August 26, 2024

**Re: Responses to the Community Meeting Comments for Peeler Road Shared Use Path from Lakeside Drive to Winters Chapel Road**

Figure 1. Typical Section – Shared Use Path on the north side and existing sidewalk on the south side of roadway (looking east)

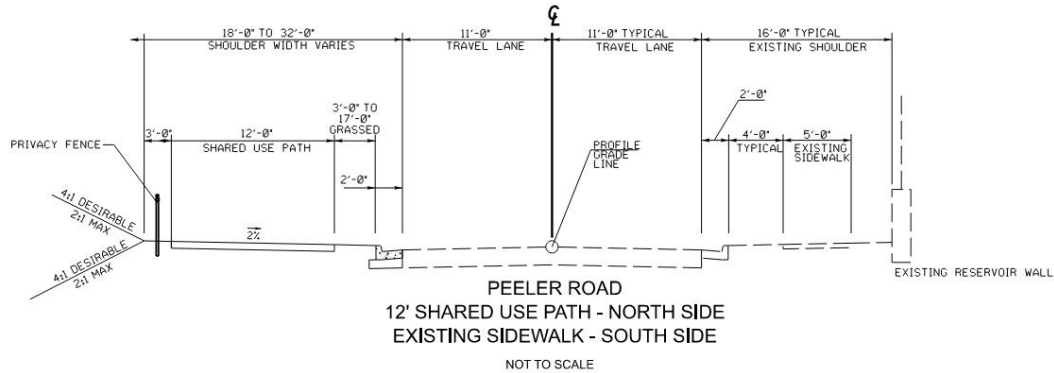
3. *Comments regarding the necessity of the shared use path on the north side of Peeler Road, given the presence of an existing sidewalk on the south side of the road. In addition, concerns were expressed about potential low usage.*

In evaluating city projects, our staff ensures that project designs protect neighboring properties, natural resources, and are cost-effective. City standards are to provide a pedestrian facility on both sides of main roadways to provide connectivity from adjacent neighborhoods to key destinations in the area.

If the shared-use path was constructed along the southern side of the roadway the existing sidewalk would be reconstructed, a 6-foot sidewalk would be proposed along the north side of the road and require a shift of the travel lane and shoulder to the north bringing traffic closer to

properties on the north side of Peeler Road. See Figure 1 depicting the shared use path on the north side of Peeler Road.
